AGENDA REPORT SUMMARY

Meeting Date: January 25, 2022

Subject Proposed Three-Story Multiple-Family Residential at 440 First Street

FRONT ELEVATION: CURRENTLY PROPOSED

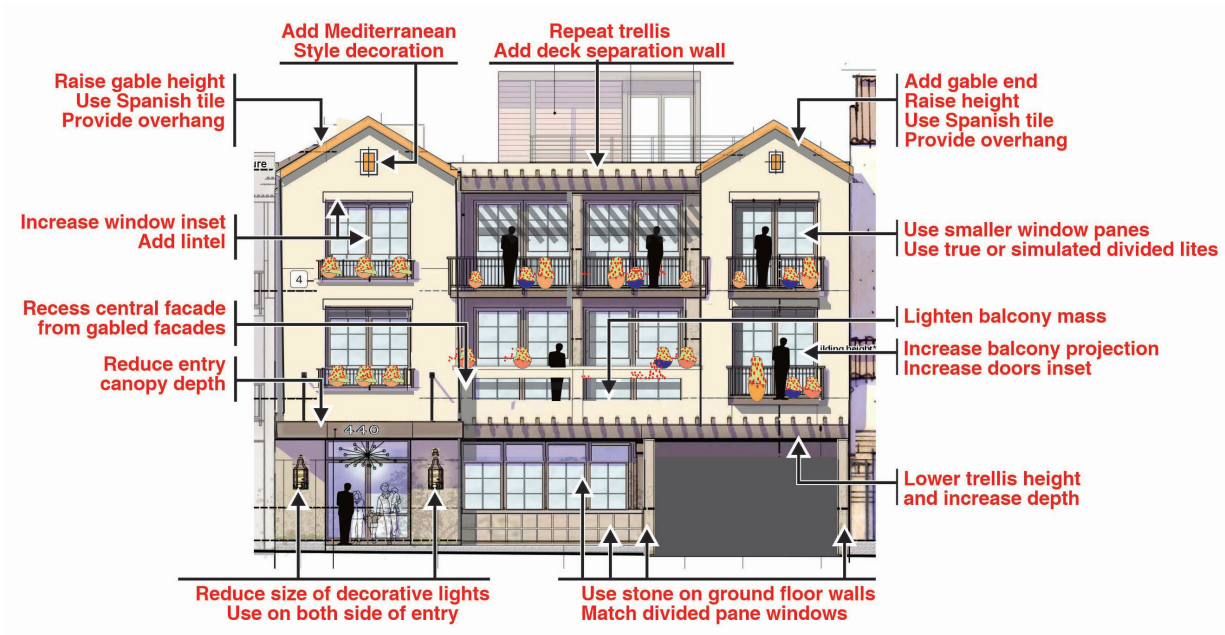
FRONT ELEVATION: RECOMMENDED

REAR ELEVATION: RECOMMENDED
Match front elevation details

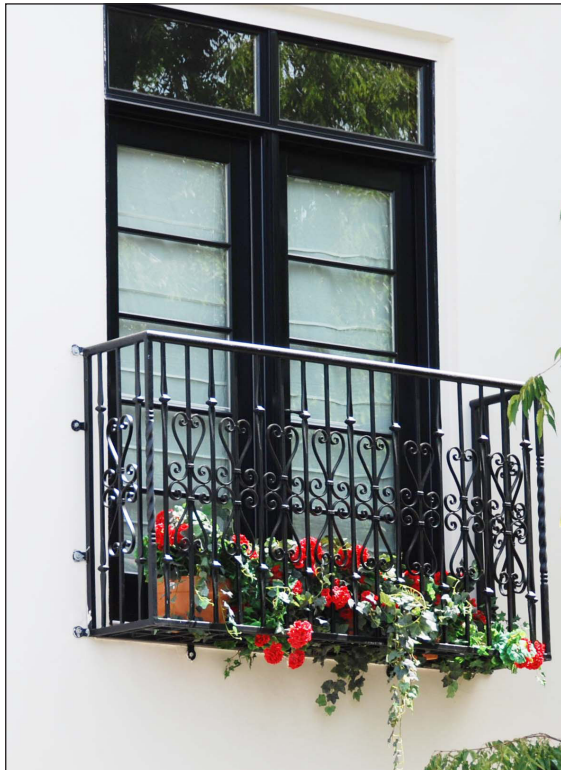
Match the rear facade changes to the front facade recommendations.
